BACK RIVER PROJECT Responses to Information Requests for Water Licence (2AM-BRP1831) Amendment

November 30, 2020

Responses to Water Licence Amendment IRs

Figure KIA-04a: Winter Range of the Bathurst Caribou Herd and the Winter Ice Road

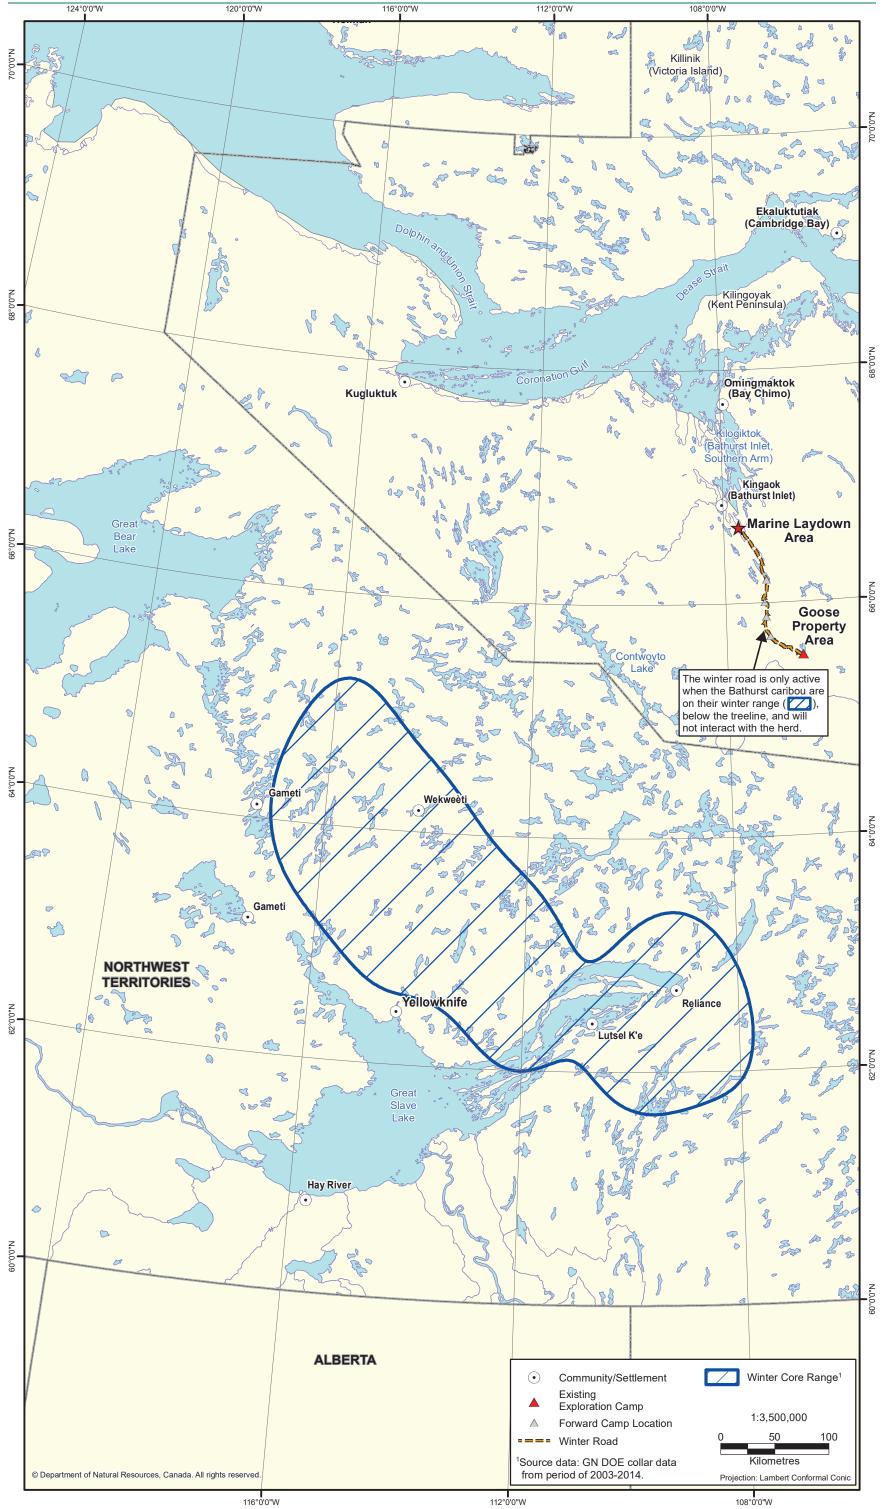
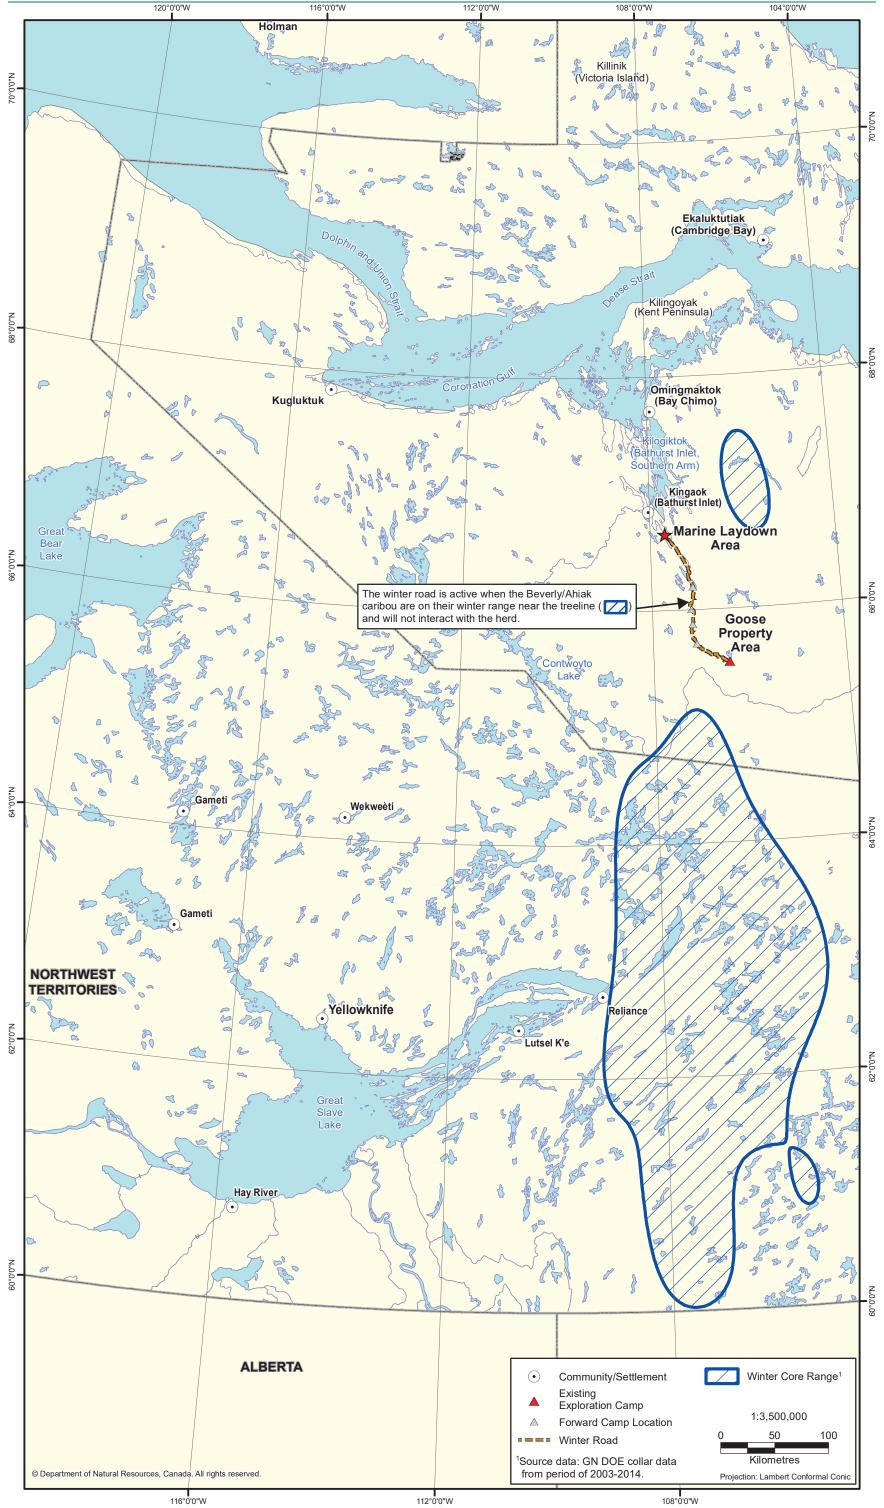
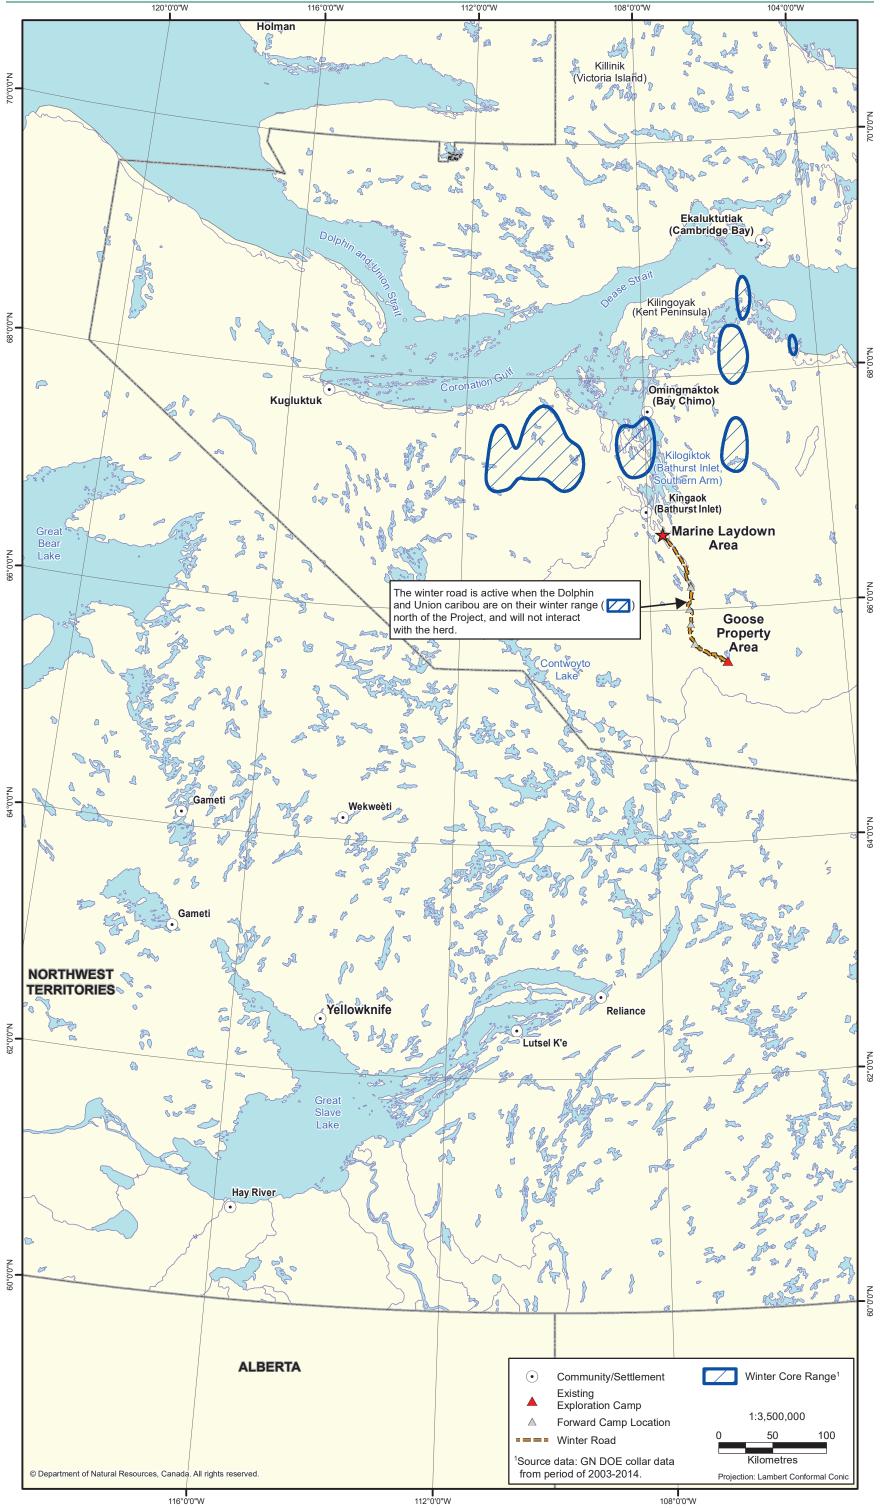
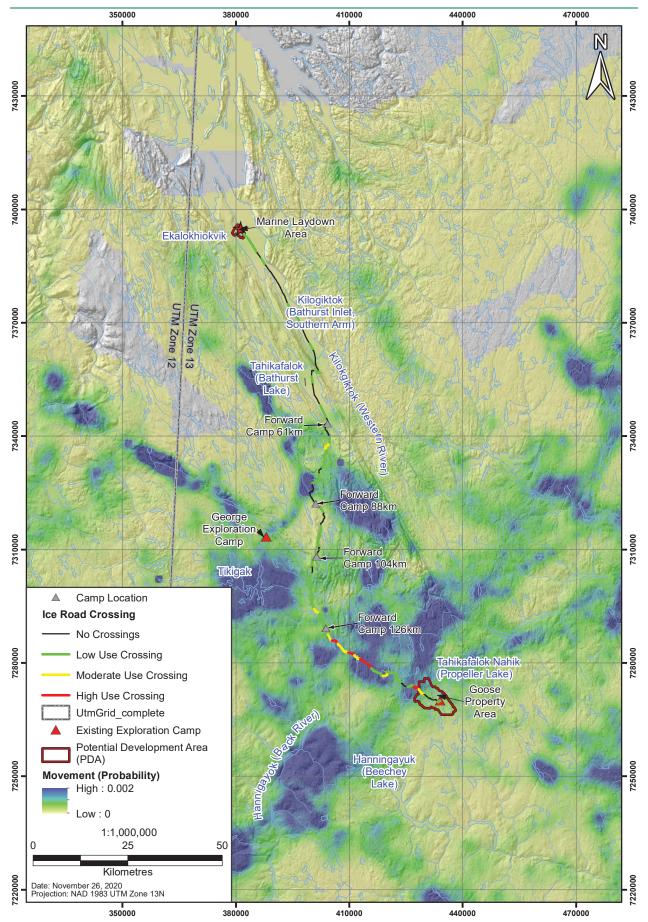
- Please confirm the date by which winter ice road service/emergency camps would be erected and operational, and when they would cease operating each year;
- Please confirm whether road service/emergency camps would remain in place permanently for the life of the project, and if so, provide information on the date by which, and how, they would be secured from wildlife access during the period of non-use;
- Please identify locations of proposed WIR camps on maps that show their respective positions in relation to existing caribou habitat (particularly winter habitat and fall and spring migration routes/ice crossings) and potential denning habitat;
- Update management plans to incorporate all prior BearWise recommendations, as the issue of bear attraction will be greater and more spatially dispersed given the proposed change in winter ice road construction plans

Although caribou and vegetation considerations do not form part of the Nunavut Water Board process Sabina is opting to provide a response to KIA. Winter habitat for caribou does not overlap with the camps. The Island caribou (Dolphin and Union) winter on both east and west of Bathurst Inlet, but to the north of the Project (Figure KIA-04-A). Both the Bathurst and Beverly/Ahiak winter predominantly near the tree-line, far south of the Project while the WIR is operational (KIA-04-B and C). During spring migration, some animals from the Beverly/Ahiak herd migration through the route of the WIR. Note that the WIR is planned to be closed on April 15 each year prior to the spring migration, to reduce the number of animals that will interact with the operating WIR. To examine movement corridors and camp, Figure KIA-04-D displays the probability of a caribou collar moving through the Project area during spring migration using a Brownian Bridge model. This output produces a probability of observing a caribou moving through a particular part of the landscape with darker shades meaning higher probability a caribou has moved through that area. Figure KIA-04-D also displays the frequency of collared caribou crossing the WIR route during spring migration (black = zero crossings, green = 1 or 2 crossings, yellow = 3-5 crossings, and red is 6-7 crossings for the period 2012-2018. Figure KIA-04-D shows that the majority of caribou that cross the WIR route do so at the southern end of the WIR, near the Goose Site. The three road camps do not overlap with areas of higher movement or road crossing.

Figure CIRNA-7-1 Culvert Catchment Map

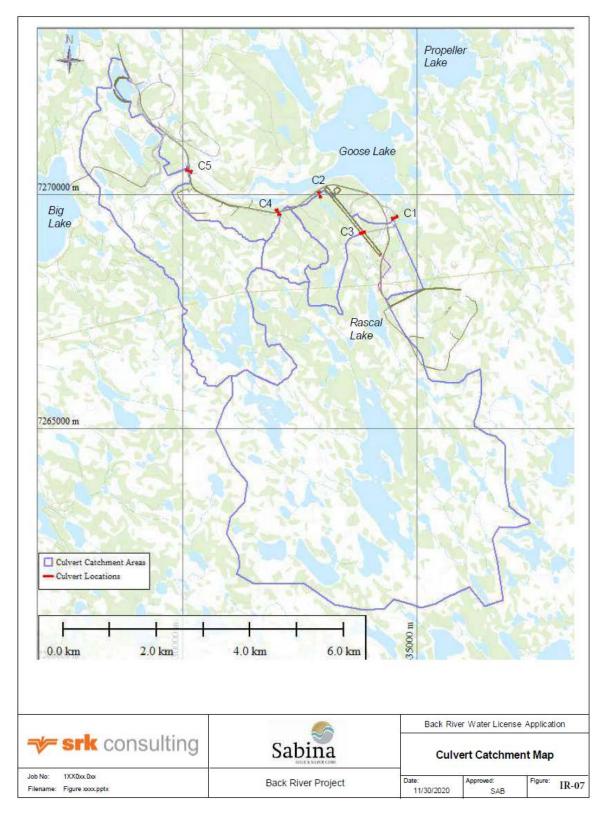
7.2. CIRNAC also recommends that the Applicant provide the watershed areas for the five culverts presented in Table 6.5-1 and compare the listed 100-year design flows with the 100-year discharges from the index curve and SCS methods presented in Figures 3.7 and 3.8 from SRK's 2015 hydrology report. The comparison can provide a reasonableness check on the peak flows determined by other methods.

Catchment areas for culverts are presented in Figure CIRNA-7-1.
